Contract #: 04-0120F4Cty: SF/ALA Rte: 80 PM: 13.2/13.9File #: 69.25B**QUALITY ASSURANCE -- NON-CONFORMANCE REPORT****Location:** Changxing Island, Shanghai, P.R. China**Report No:** NCR-000750**Prime Contractor:** American Bridge/Fluor Enterprises, a JV**Date:** 28-May-2010**Submitting Contractor:** Zhenhua Port Machinery Company, Ltd (ZPMC), Changxing Island**NCR #:** ZPMC-0713**Type of problem:**

**Reference Description:** Excessive heat was utilized during heat straightening of the traveler rail 20TR2-013**Description of Non-Conformance:**

**Dear:** Mr. Charles Kanapicki  
**Job Name:** SAS Superstructure

**Subject:** NCR No. ZPMC-0713

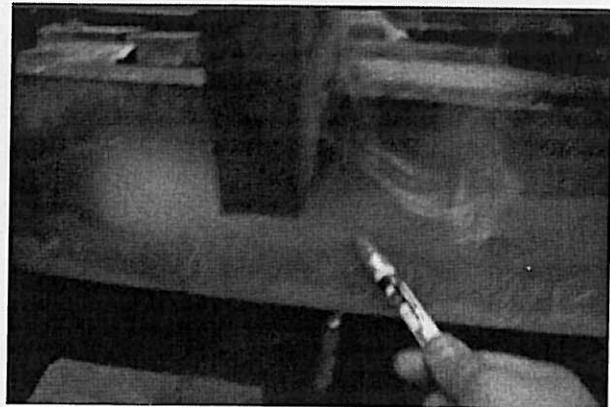
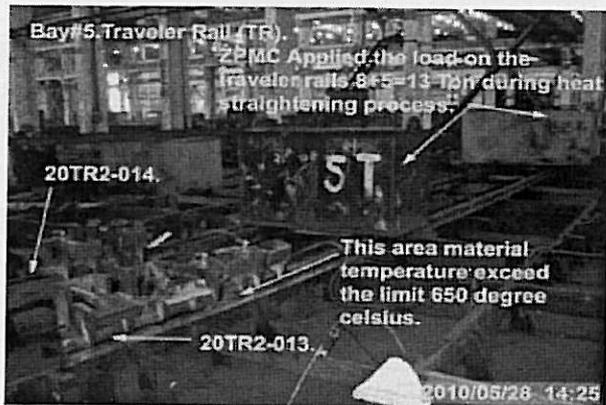
- ZPMC personnel performed heat straightening of the traveler rail flange base plate. The material was heated to a bright red condition and the temperature is above 650°C.

- Per ZPMC Heat Straightening Report identified as HSR1 (B)-8350, the maximum allowable temperature is 650°C.
- The AWS D1.5 Section 3.7.3 states that the heated steel shall not exceed 650°C, which gives a dull red color.

- This QA Inspector observed the 760°C Tempilstik was melted when struck against the red base metal.
- A temperature indicating crayon, digital temperature measurement gauge, or other similar means of monitoring the temperature was not utilized by ZPMC QC and the actual maximum attained temperature was not measured.

- The Traveler rail is identified as 20TR2-013.
- The affected area was measured at Y location 800mm when measured from nearest leading edge, having a total area 150 x 1200mm.

- Additionally, this QA Inspector observed ZPMC apply a 13 Tons load on the Traveler rail.
- ZPMC HSR1 Report doesn't specify the exact weight or weight range to be applied on the TR during heat straightening process.

ZPMC SHANGHAI ZHENGLIAO PORT MACHINERY CO., LTD.		WELDING MAP	
		DRAWN CHECKED	PROJECT DRAWING NO. 11TR11

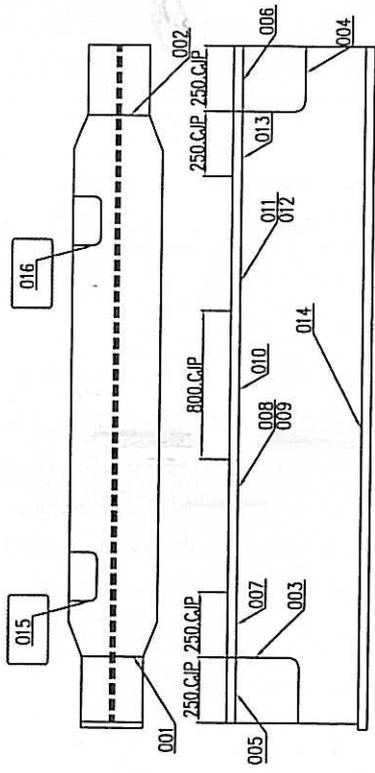
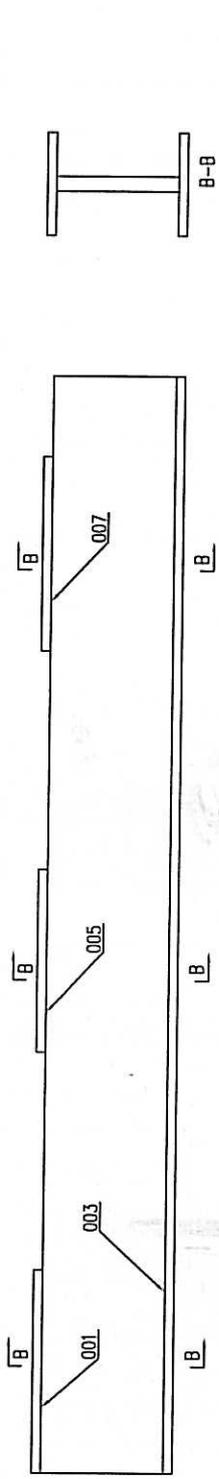
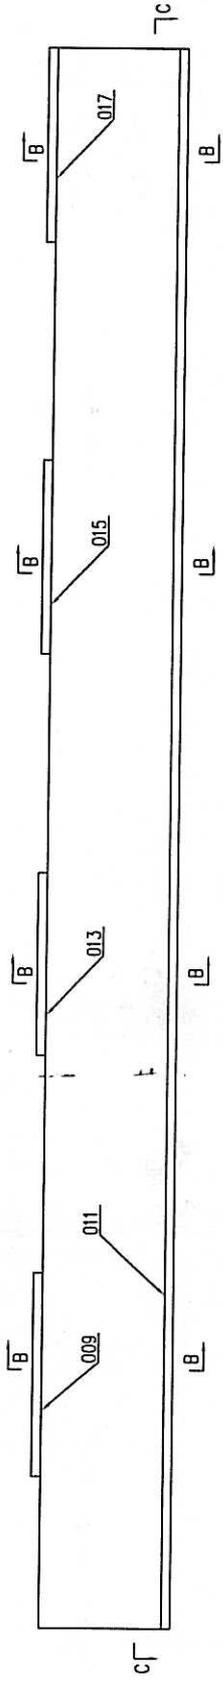
The Contractor has supplied the post repair NDT, but the reports are labeled post HSR. The reports need to be labeled to show that the NDT was performed after the pieces were replaced and what they were replaced with. A copy of the updated weld maps for the newly added welds is also needed.

**Reference Resolution:** ZPMC is providing the weld maps requested in the Department's previous response for the repairs made after testing to the traveler rails in ZPMC-0713 and ZPMC-0662.

ZPMC is providing the weld maps requested in the Department's previous response for the repairs made after testing to the traveler rails in ZPMC-0713 and ZPMC-0662. Previously submitted NDT was labeled post HSR because the parts were heat straightened after the test areas were re welded. Based on this and previously submitted NDT, ZPMC requests closure of this NCR.

Heat Straightenings were performed to these rails after the pieces were replaced. The submitted NDT records in the previously documentation are reflecting to these Heat Straightenings and are labeled post HSR. ZPMC is providing the revised weld maps for engineer's reviewal. Based on this, please consider closure of these NCRs.
